ADDENDUM NO. 1
TO
BIDDING AND CONTRACT
REQUIREMENTS AND SPECIFICATIONS
FOR THE
15 COLUMBIA STREET AND 19 UNION STREET
PARKING LOT REHABILITATION
AUGUSTA, ME
WP PROJECT NO. 14105A

4/26/2019

ADDENDUM NO. 1

WP PROJECT NO. 14105A

FIGURE 1:

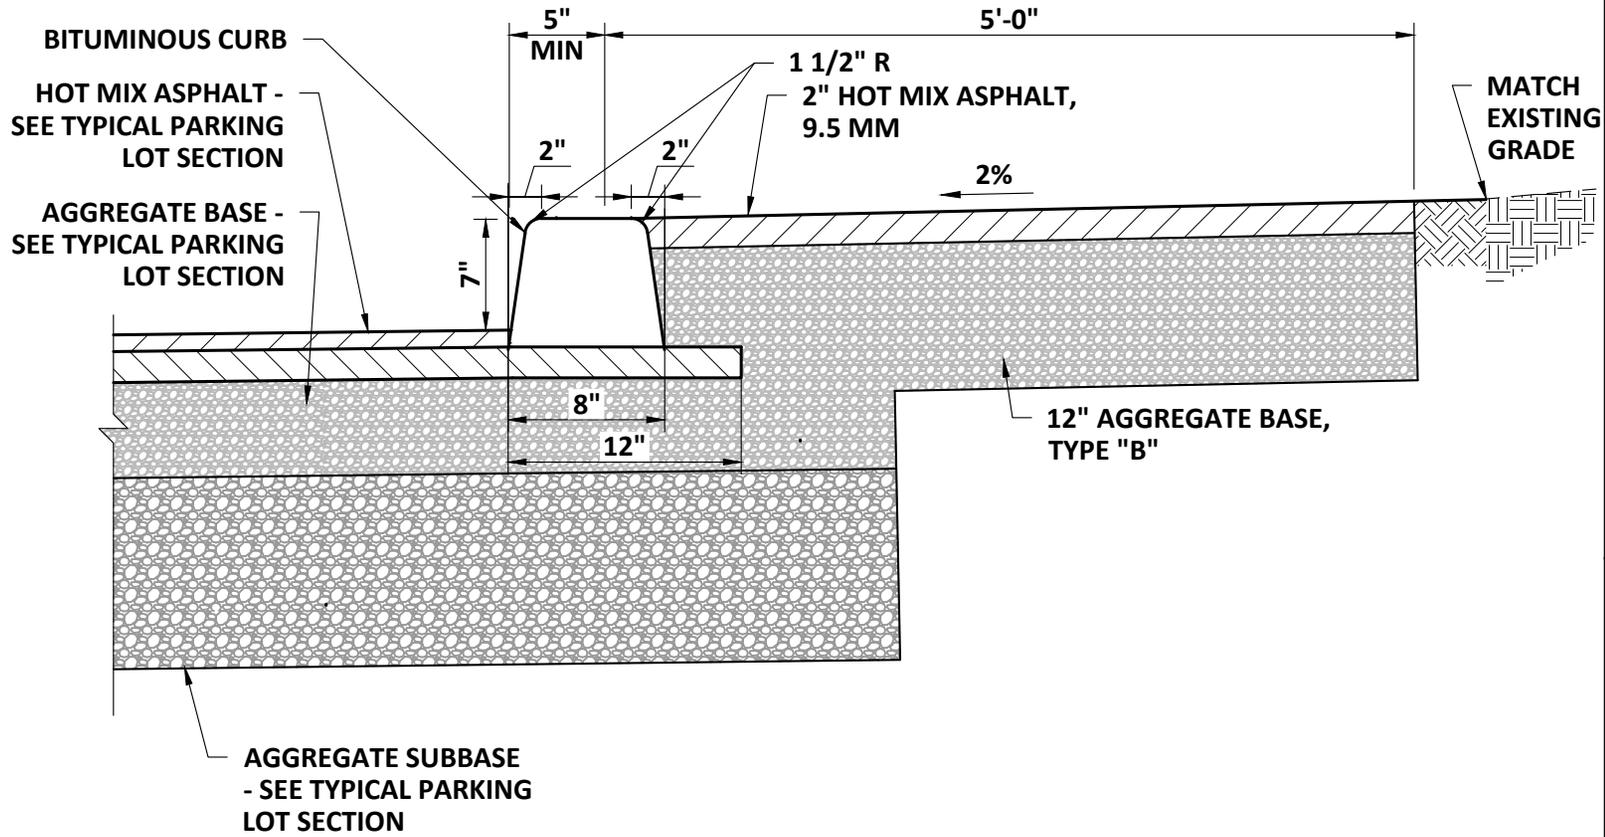
1. Bituminous Curb Detail

BITUMINOUS CURB W/ SIDEWALK
